# Building and Environment Assessment of Dr. H. Mezger School Melela

Figure 1: Cracks in girls' toilet building

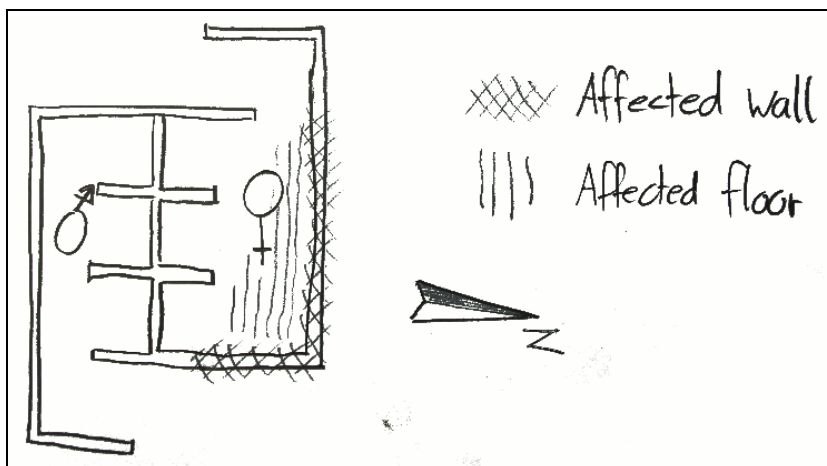
There are cracks in the bricklayer wall of the student's toilet building (see Figure 1 and Figure 2). Furthermore the floor sunk down in some parts.

These problems are obviously caused by improper constructed foundations at the north-east corner of the building (compare Figure 3)

The building parts which are not signed as affected in Figure 3 are still in a good general condition. Therefore it is recommendable to repair the occurred effects instead of rebuilding the complete building (unless the toilet building should be lifted on a higher standard or have to be bigger because of the increasing number of students). For the repair works the affected walls must be disassembled and the foundations must be reinforced or completely changed in the affected area.

**Figure 7:** Rain water and drinking water

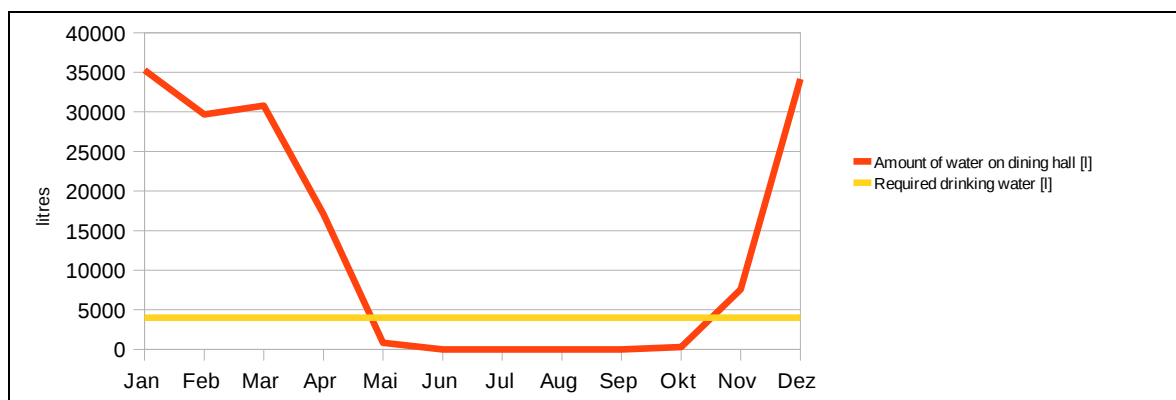
Getting exact data of the weather and rain in Melela is not very easy. Figure 7 is based on the climate data of Dodoma. The red curve shows the possible rainfall on an area with a size of 280m<sup>2</sup>. This is equal to the roof area of the dining hall.

The amount of rain falling on the dining hall is 3 times bigger than the consumption per year. During almost 6 months the rainfall is smaller than the consumption.

To store water for full year usage there would be a need of approximately 24 000 litres capacity of water storage. Please remember that such a big amount of water must be conserved adequately. This is probably only with chemical additives possible because the water is getting quite hot in black polytanks.

To buffer water as drink water supply during the rain season a capacity of 2 000 litres would be sufficient if there is a strong rain event once in two weeks time or one midrange rain once in a week. According own experiences this should be very likely.

Figure 8: Ground view of possible rain water supply

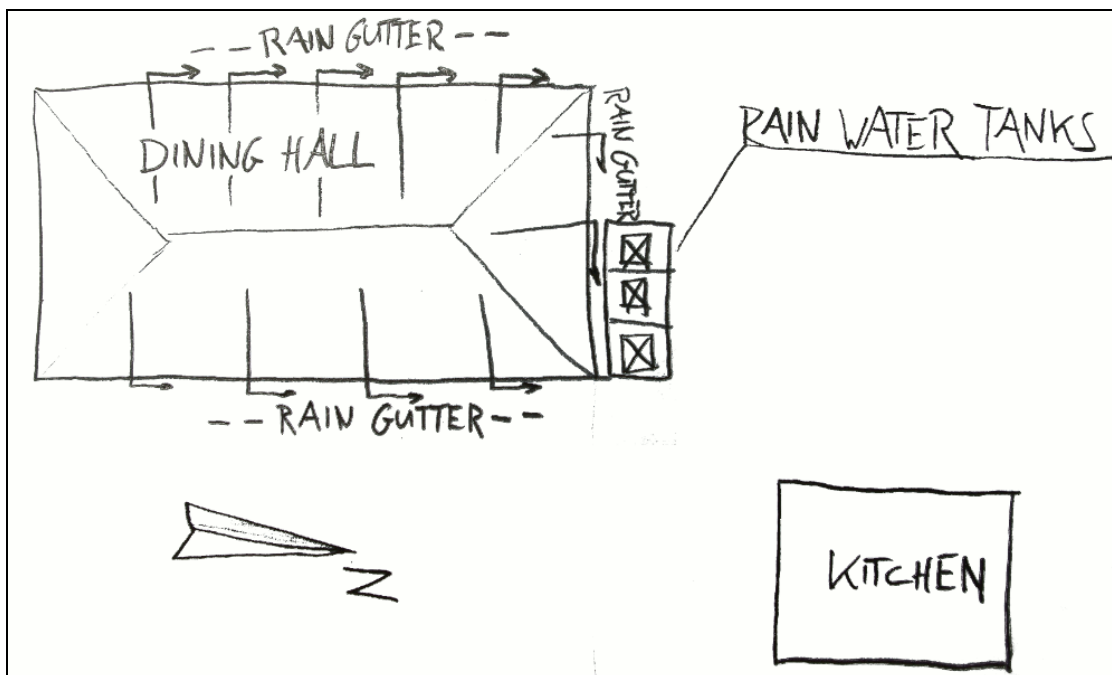
Figure 8 shows a possible location for the polytanks for the rain water storage.

Figure 9: Side view (East) of possible rain water tanks

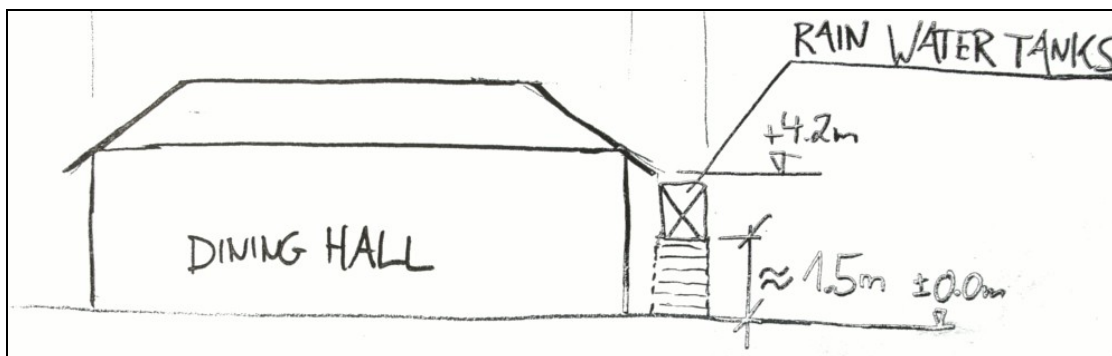
Below in Figure 9 one can see a possible elevation. The chosen place is so far not occupied by other building parts and furthermore the filling a well as the emptying can be achieved without using any pumps.

Figure 10: Possible arrangement of the guest house buildings

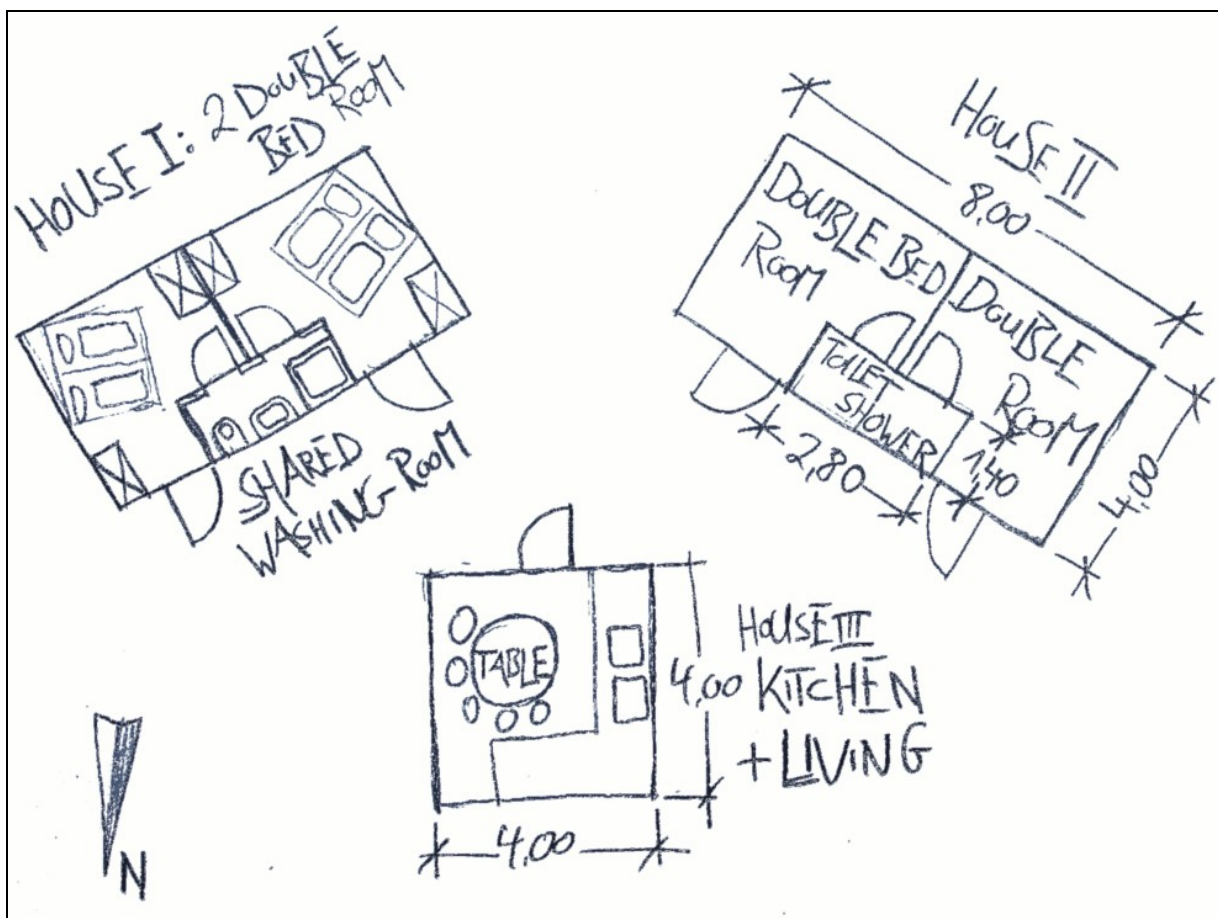
The Figure 10 shows a possible arrangement of guest houses. The idea is that there is one shared bathroom for two double bed rooms. In this case the houses can either used by one family each or even by two independent parties. Furthermore we assumed to have a third building which accommodates a kitchen and living room in one. According own experiences people meet were there is food ;-)

The advantage of this solution is the fact that there is space for privacy as well as for the commune. Because of the limited size of the houses it may be built by using simple construction methods. We recommend to use bricklayer walls with open windows without glass and a timber roof structure with metal decking. These are common methods of construction in the area and are comparably cheap and good.
